**Re: New Well (L15811) and 2,500-Gallon Tank (PR#46-2018)  
Camp Cooper BSA (PWS ID#92088)  
Final Approval**

Camp Cooper BSA (PWS ID #92088) – New Well (L15811) and 2,500 GAL PE Tank

PR# 46-2018 – Final Plan Approval

STATE OF OREGON  
**WATER SUPPLY WELL REPORT**  
 (as required by ORS 537.765 & OAR 690-205-0210)

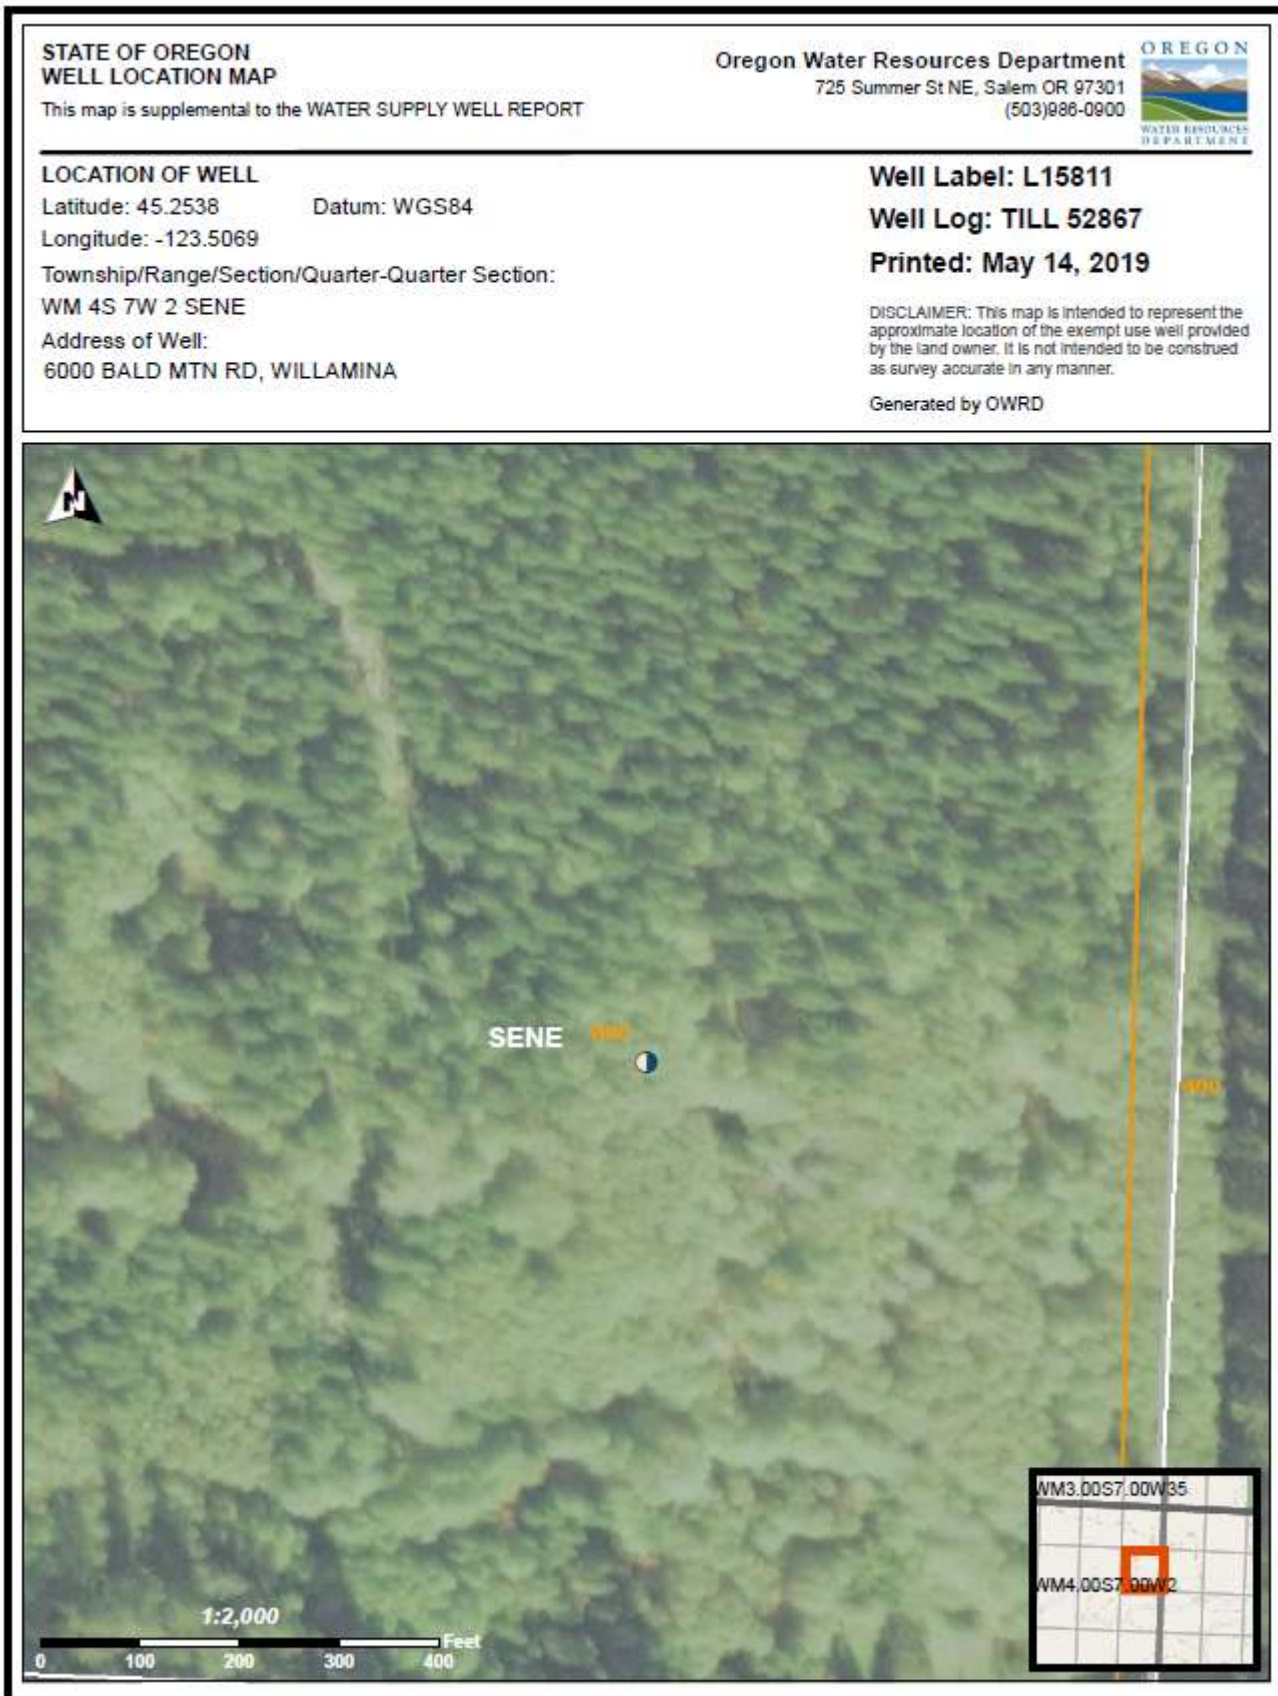
Comments: This is a dug well that extends to a depth of 16.4 ft. The casing consists of pre-cast 48-inch diameter concrete rings that extend to the bottom of the hole. The casing is sealed to a depth of 12.4 ft. Water enters the well through casing perforations below the casing seal. The immediate area around the casing is capped with an 80 mil HDPE containment blanket to help guard against surface/storm water intrusion into the well. The containment blanket is overlain by native fill. Sensitivity Analysis results suggest that well construction is not sensitive to nearby land use practices.

Comments: This well draws water from a very shallow semi-confined gravel aquifer. The silt/clay layer above the water-bearing zone is only 8 ft thick and therefore may not be as protective to the water-bearing zone as a thicker clay/silt might be. The static water-level in the well was reported to be 10.8 ft above ground level, about 19.5 ft above the top of the water-bearing gravel located at 8.7 ft below ground level. Due to the reported flowing artesian condition of this well and the thin silt layer over the top, this aquifer is considered to be semi-confined. Sensitivity Analysis results suggest that the aquifer is highly sensitive to nearby land use practices. There do not appear to be any mappable fecal contaminant sources uphill from the well. However, given the shallow nature of the water-bearing zone (less than 10 ft below ground level), monthly source assessment monitoring should be initiated for the well (at start-up) for the months that the well is serving water to the public if the water system is to continue residual maintenance hypochlorination. If hypochlorination is discontinued, monthly distribution sampling should occur for the first year or until there is a representative distribution sample for each month that the water system is serving water to the public.

**6" OVERFLOW DETAIL**

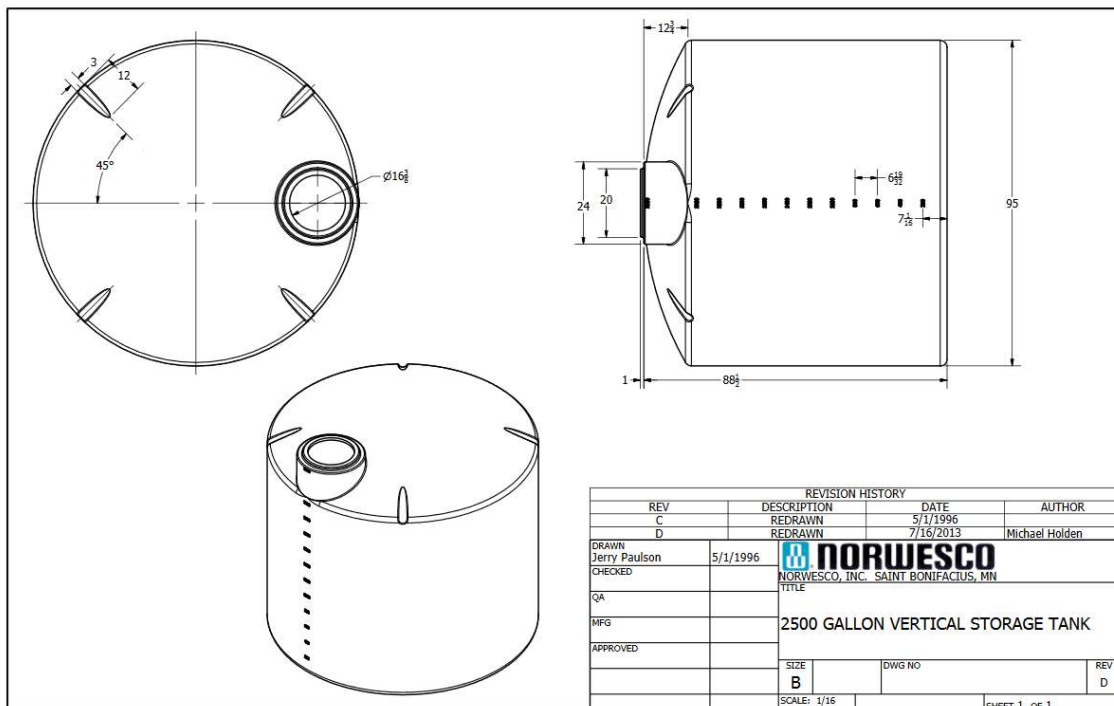
Also note, that the **overflow piping that also serves as the air vent for the NORWESCO 2,500-gallon polyethylene tank for finished water, although screened, should be fitted with a downward turned screened elbow**, such that particles cannot drop or be blown into the overflow piping and insects cannot enter the tank.
